LCD FPC BLOCK

MCU BLOCK

*** Reversion

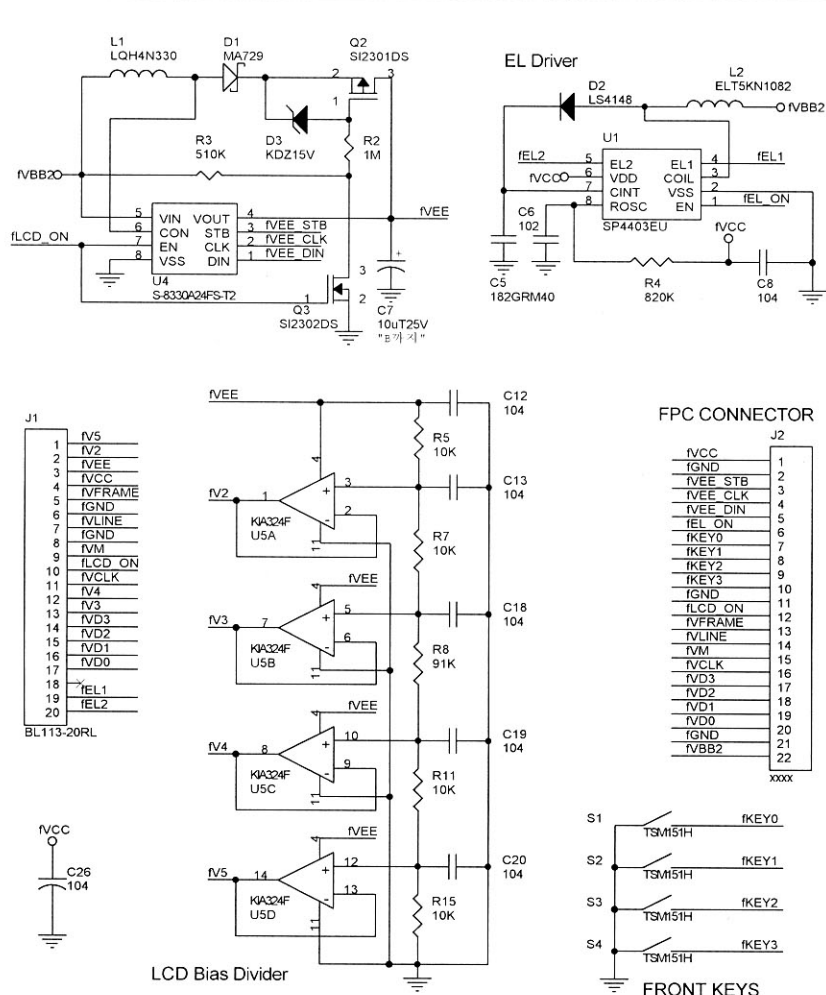
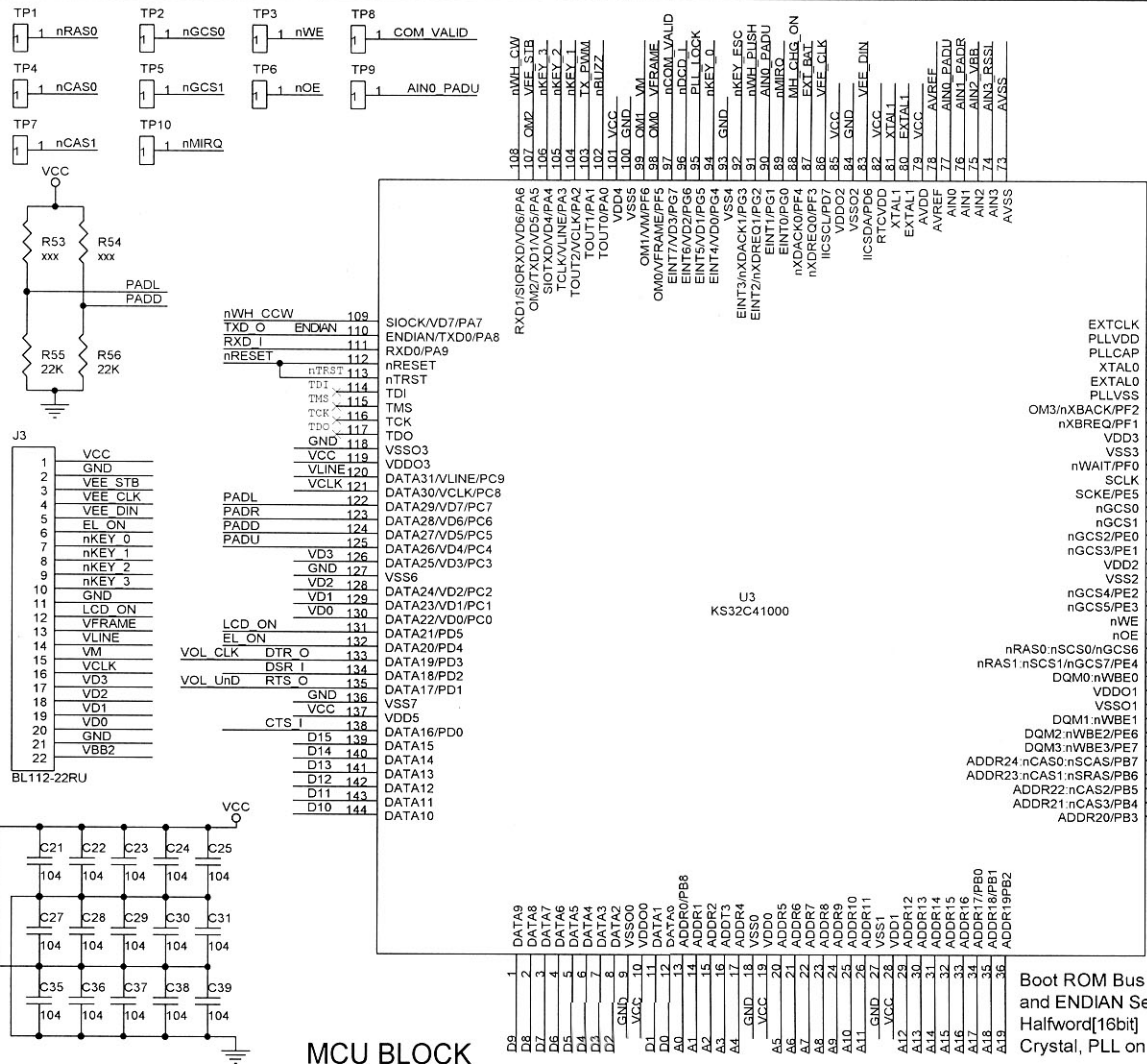
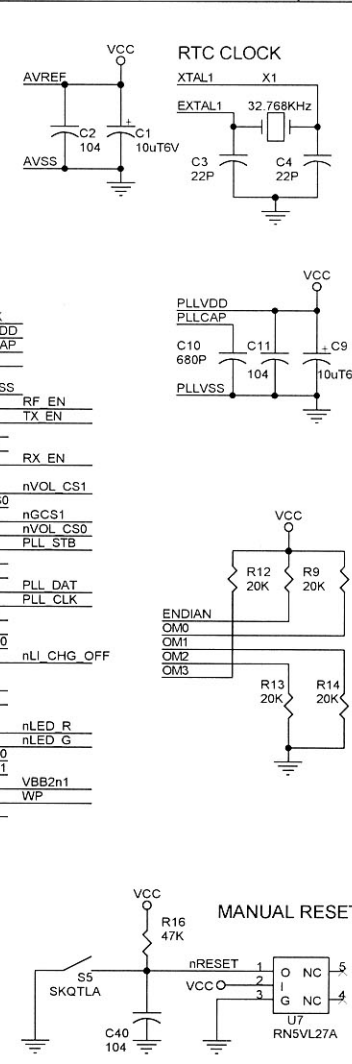
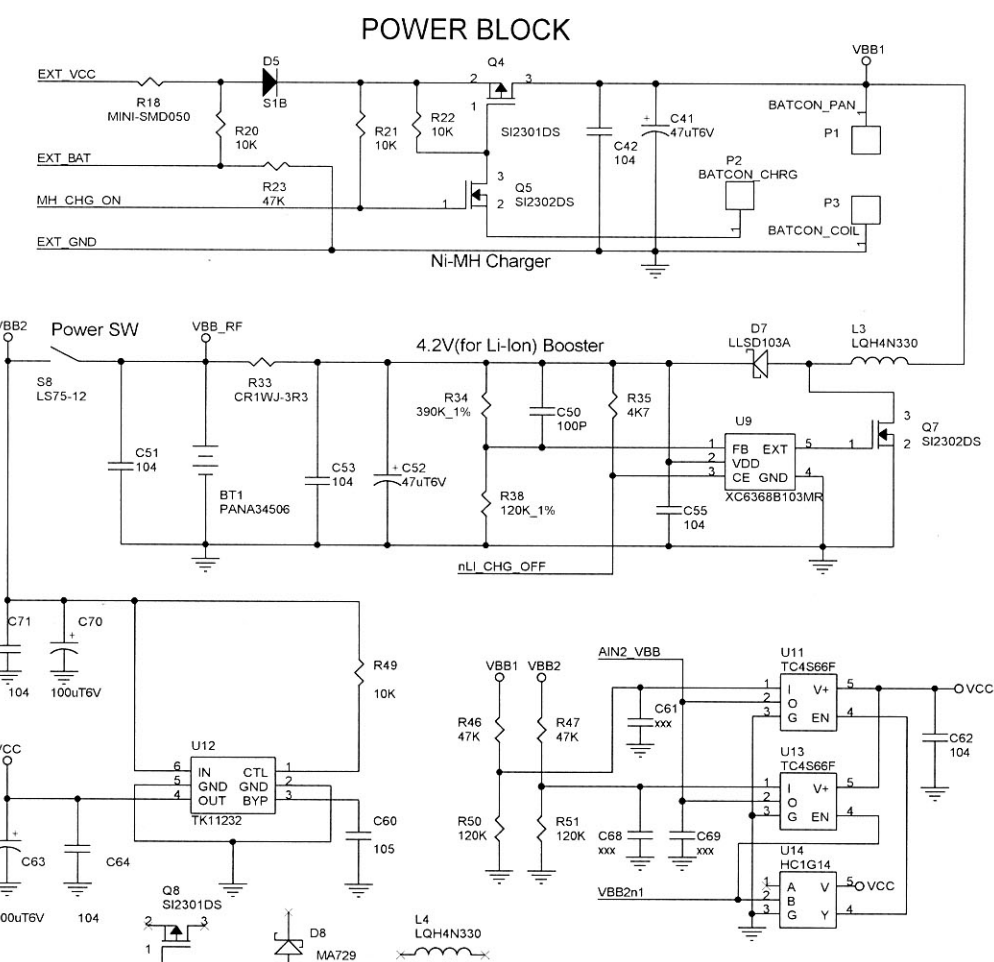
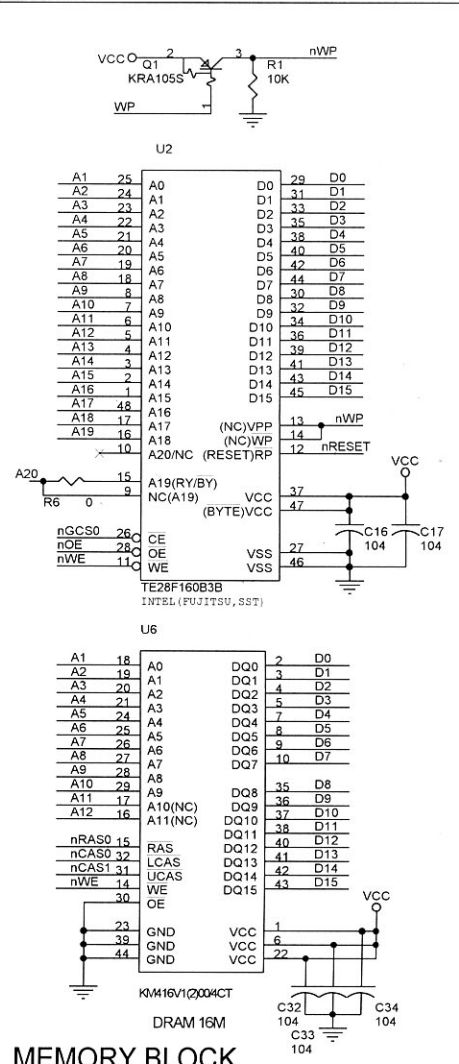
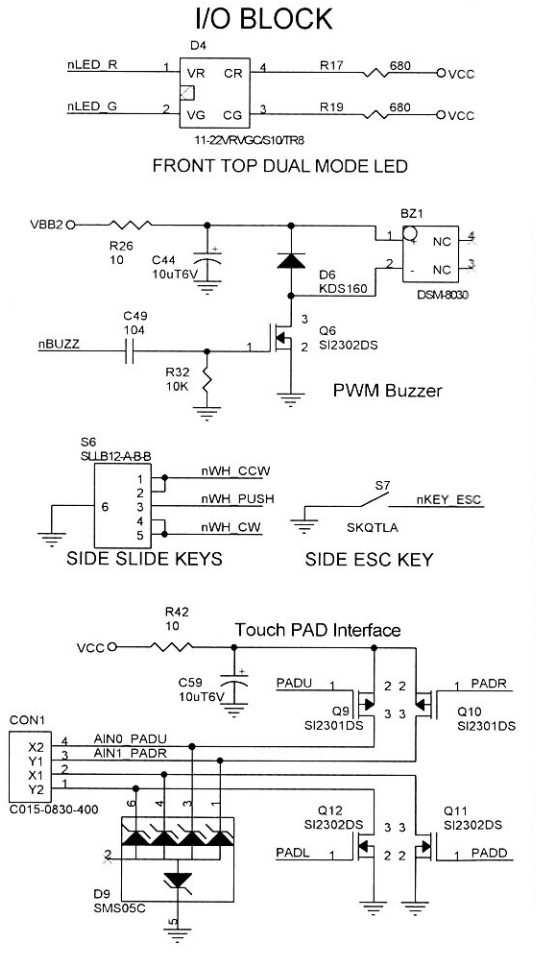
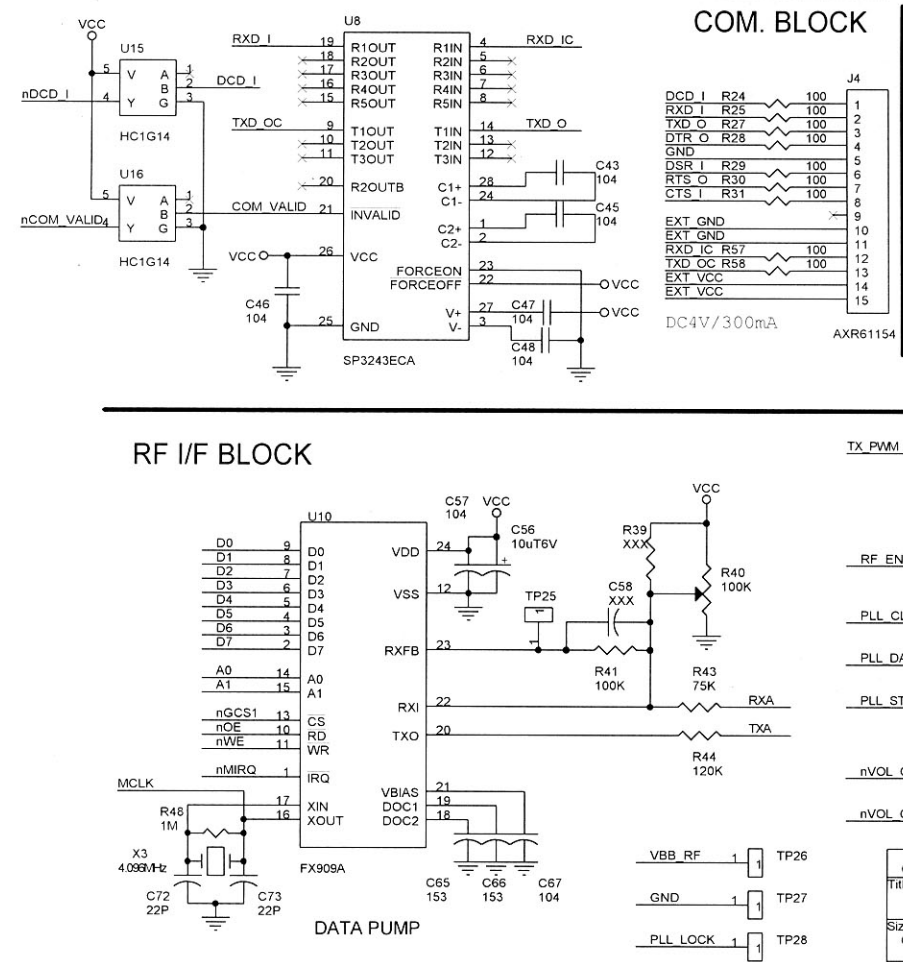
1. 외부Clock으로 교체
2000.4.11 (OM3, EXTCLK, XTAL0, EXTAL0)
2. DRAM 전원 R3C0D0를 VCC로 교체, 2000.4.18
3. VBB2를 S5 펄스원으로 이동, 2000.5.3
4. Main DC-DC Stepdown을 LDO(U12)로 교체, 2000.5.3
5. C4 104를 100으로 교체, 2000.5.3
6. R45, R52를 TP13, TP20로 이동, 2000.5.3
7. PLL LOCK(TP28) 추가, 2000.5.3
8. R53-56 Mode 3/4추가, 2000.5.3
9. U15, U16추가 및 CPU p56, p77변경, 2000.5.3
10. J4 22pin->15pin으로 변경, R57, 58 추가, 5.8
11. Buzzer쪽 R32, C49 서로 자리이동, 5.8
